Initiated By: Vincent A. Papsidero, FAICP, Planning Director
Jennifer M. Rauch, AICP, Planning Manager
Joanne Shelly, AICP, RLA, LEED BD+C, Urban Design/Landscape Architect
Re: Informal Review – Residences at Tuller Heights

Re: The Residences at Tuller Heights

CITY OF DUBLIN, FRANKLIN COUNTY, OHIO
BASIC SITE/DEVELOPMENT PLAN
 FOR
THE RESIDENCE AT TULLER HEIGHTS
 2019

CITY OF DUBLIN, FRANKLIN COUNTY, OHIO
 BASIC SITE/DEVELOPMENT PLAN
 FOR
THE RESIDENCE AT TULLER HEIGHTS
 TREE REMOVAL PLAN

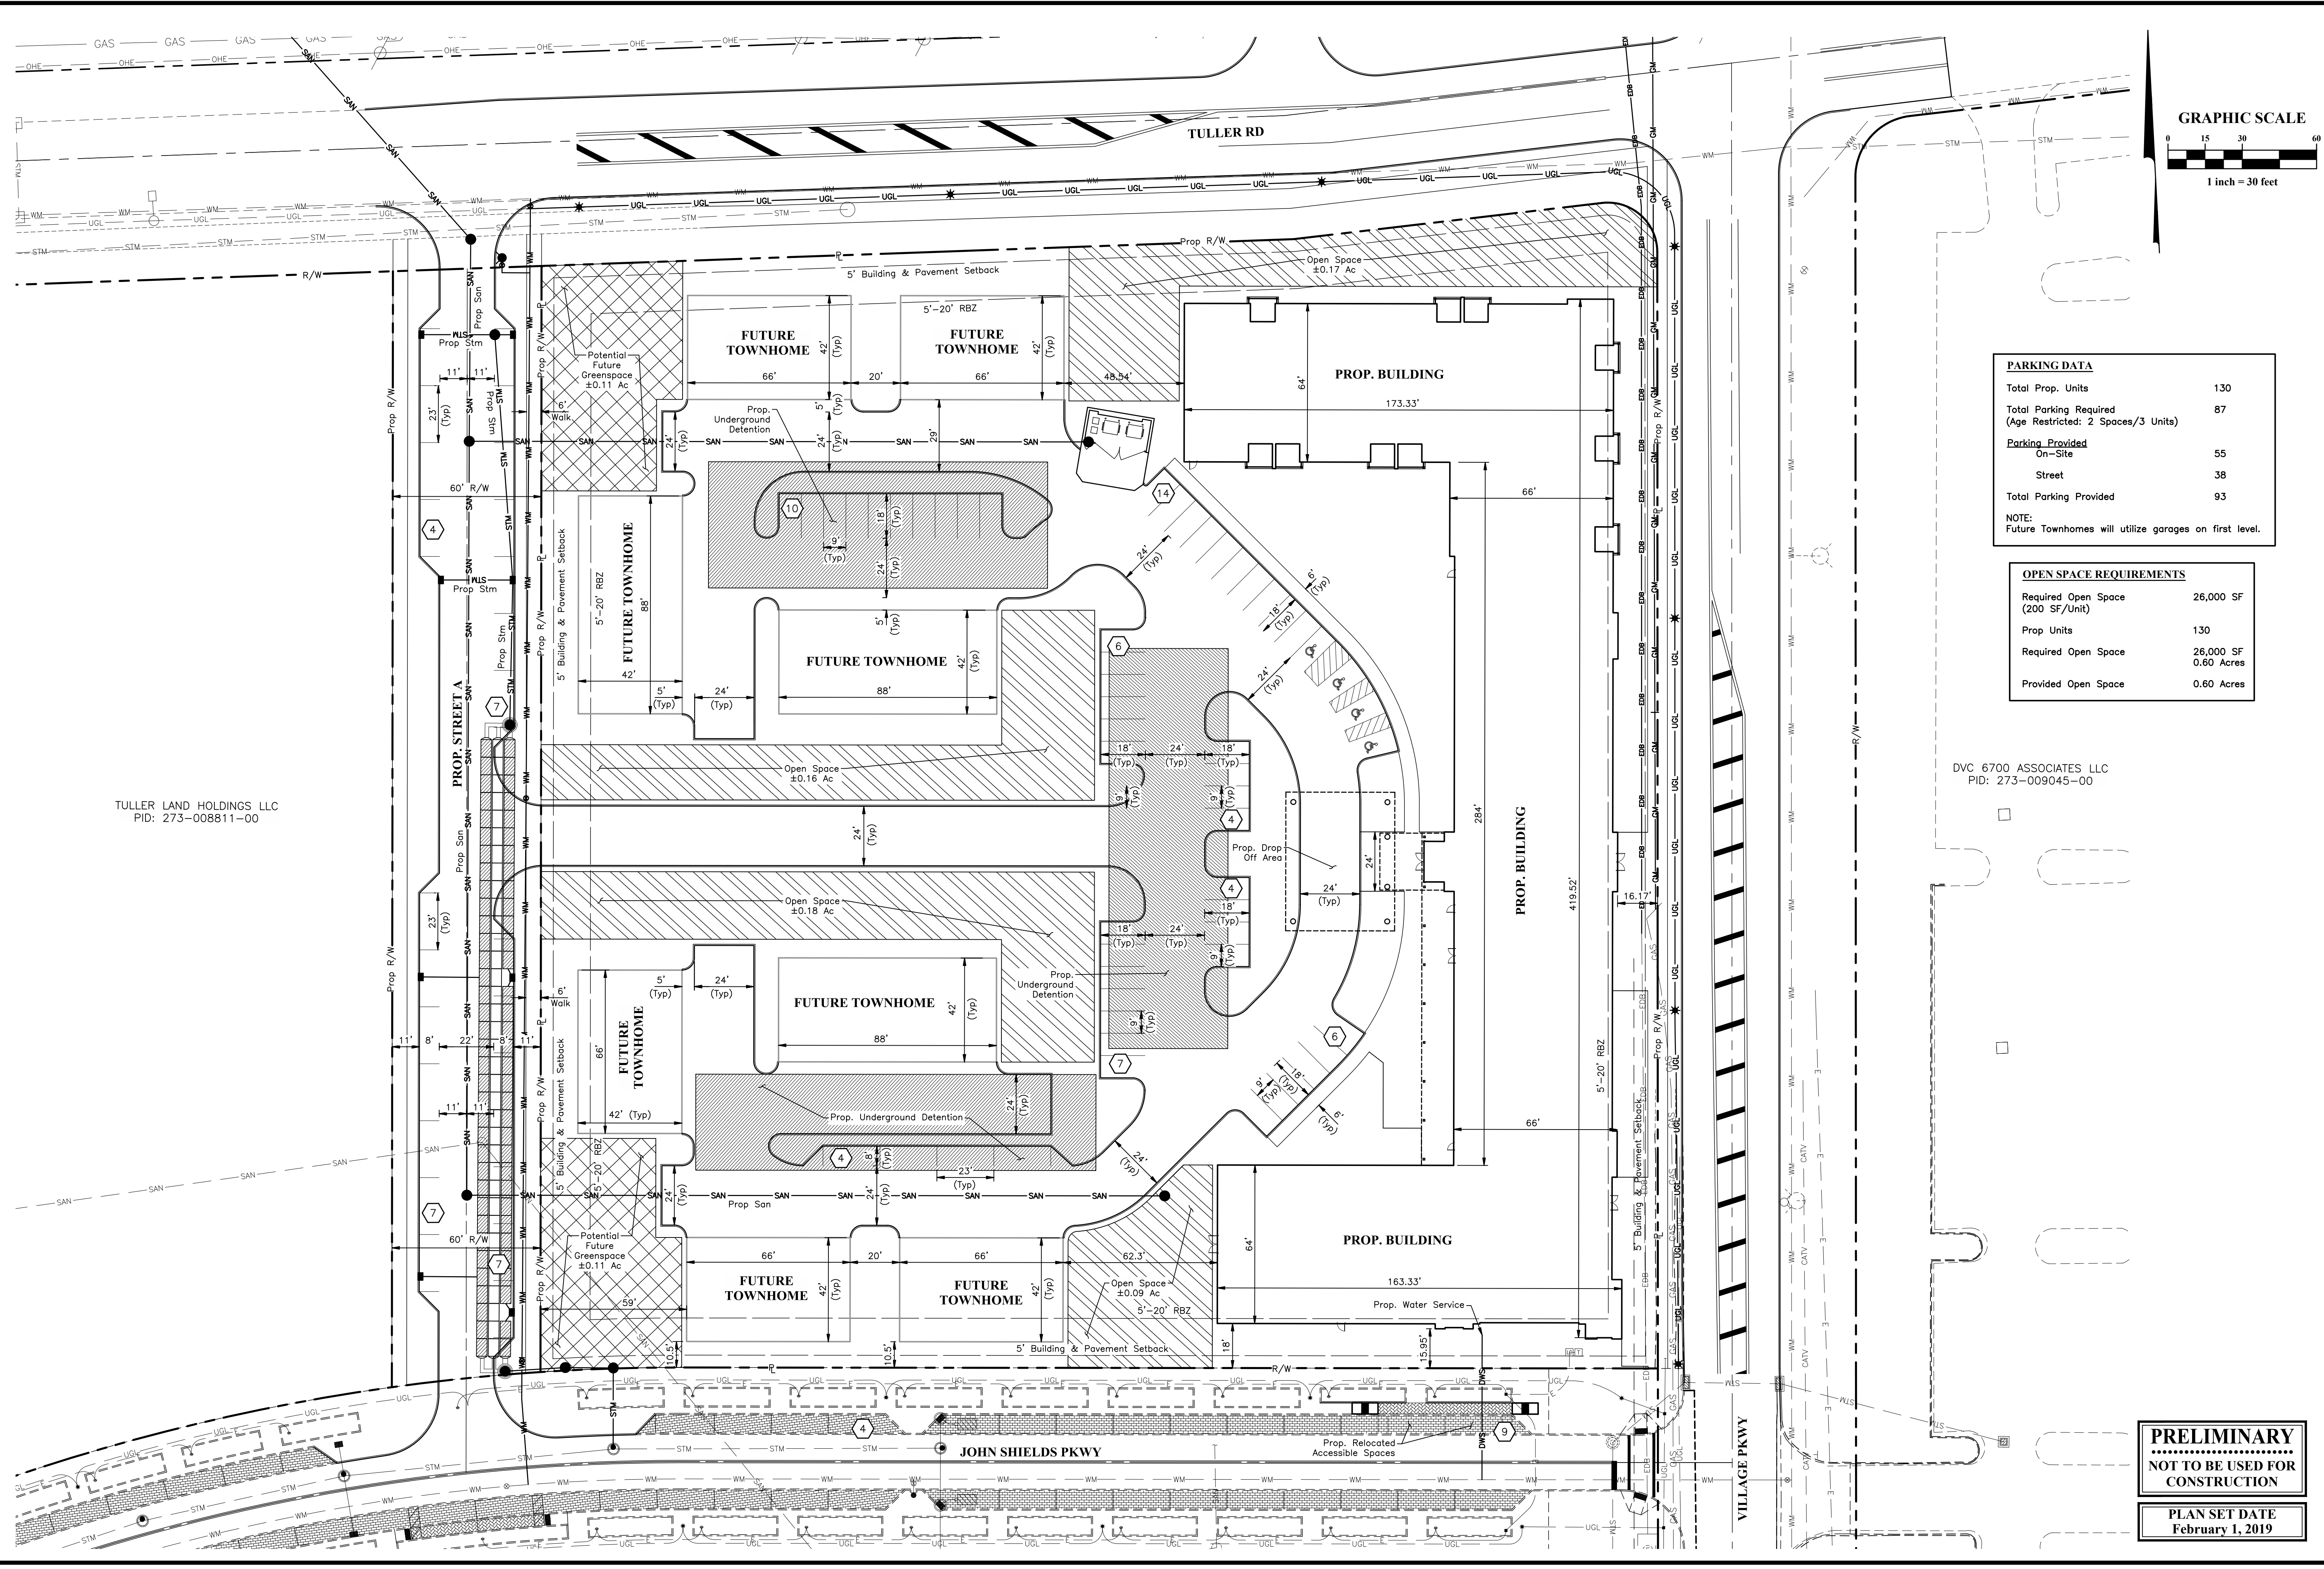
- Regarding tree removal, there are over 300 caliper inches of oak trees to be removed. None of them indicate they will be relocated; they all indicate removal. These are part of the street tree network and the City has invested many years in their growth.

Original Architectural Design

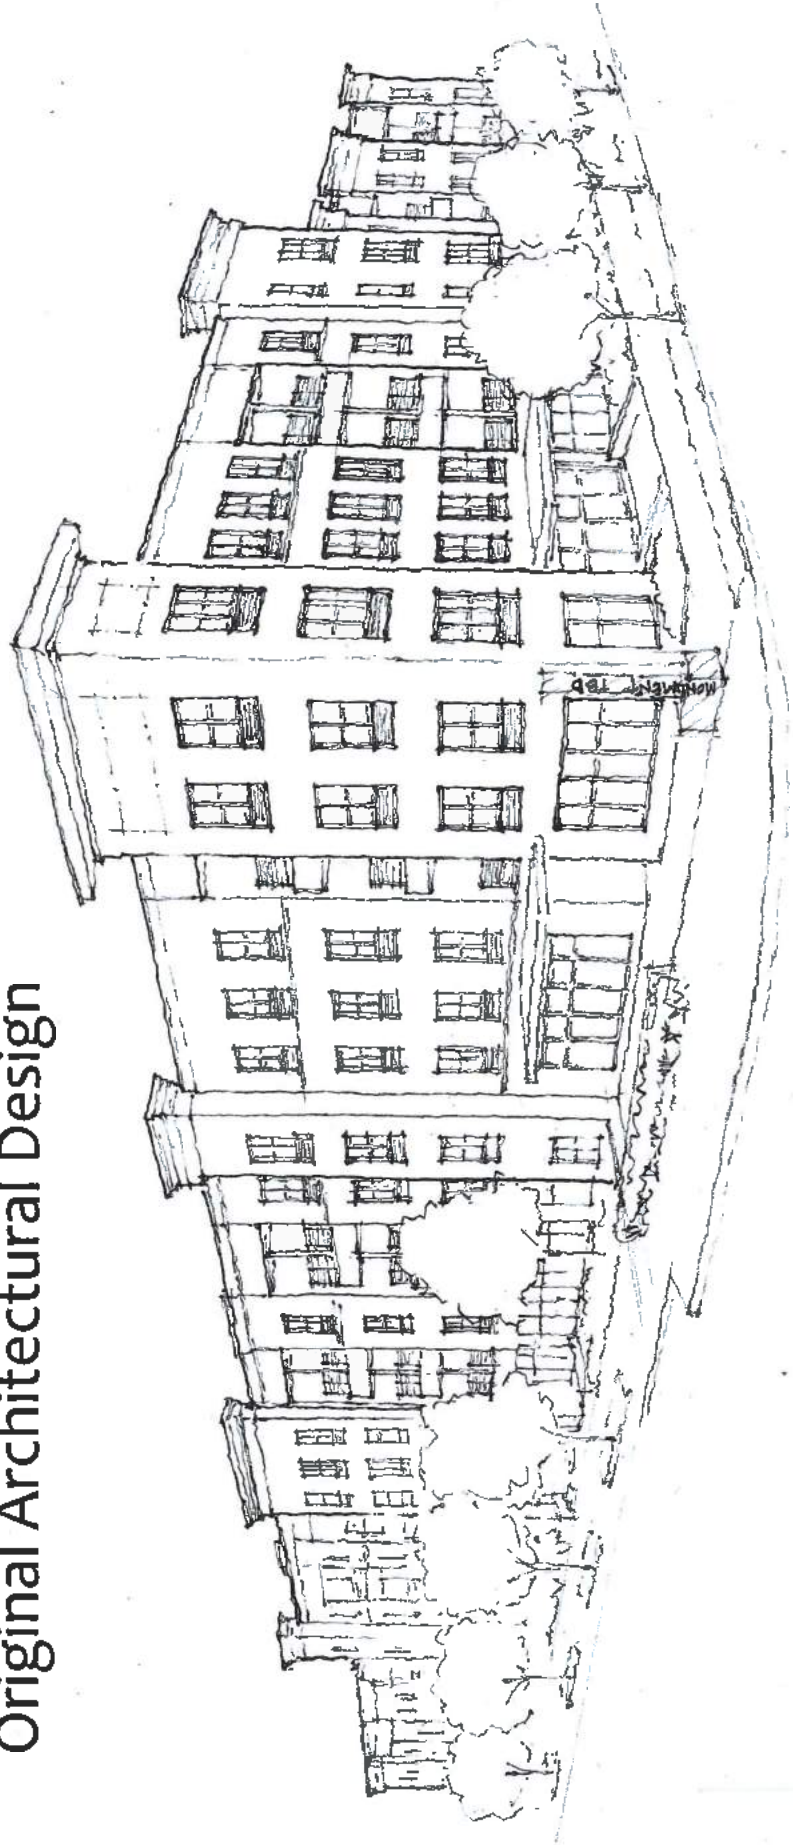
- A change in roof plane or height waiver is being requested. There is little fenestration on this building. It appears to be of two feet at most – not enough to provide a shadow line. With the change in roof plane, they are trying to accomplish a faux look of a fenestration change by changing the parapet heights. She does not believe this is an effective way to make that look attractive.

- The façade is nearly flat along John Shields Parkway. There are two sections, and if the scale is as she believes it is, the bump-outs are perhaps two feet. Aside from that, different colors of brick and siding are being put on a flat surface to make it appear as though there is some fenestration or relief. In reality, there is not.

- In regard to façade materials, there are six different colors of brick on one building. The effort seems to be on making a fake building – one building appearing as several buildings. It is not – it is one building. She would prefer to have an authentic, good building on this site.

- There is only a cornice on the one corner of the tallest tower. A building like this should have a cornice that is inclusive versus these panel parapets to make it attractive.

As to architecture, accompanying this letter you will find the originally proposed architecture which can be incorporated into the new design and complies with Code to a great extent. Alternatively, we have also included an "inspirational image" from another similar project (not developed by Graziano) that demonstrates the direction in which the architecture could be taken. The purpose of this image is not to define specific architecture for this project, but instead is to provide an example of how variations in exterior materials, alternative roof forms, and other features may be incorporated into the building's design to create a more traditional feel. Graziano is willing and able to alter the exterior design to make it more traditional and to eliminate the feeling of "more of the same" in the area. Of course, this would need to be pursued with an understanding that such a design will necessarily require various waivers from Code requirements.
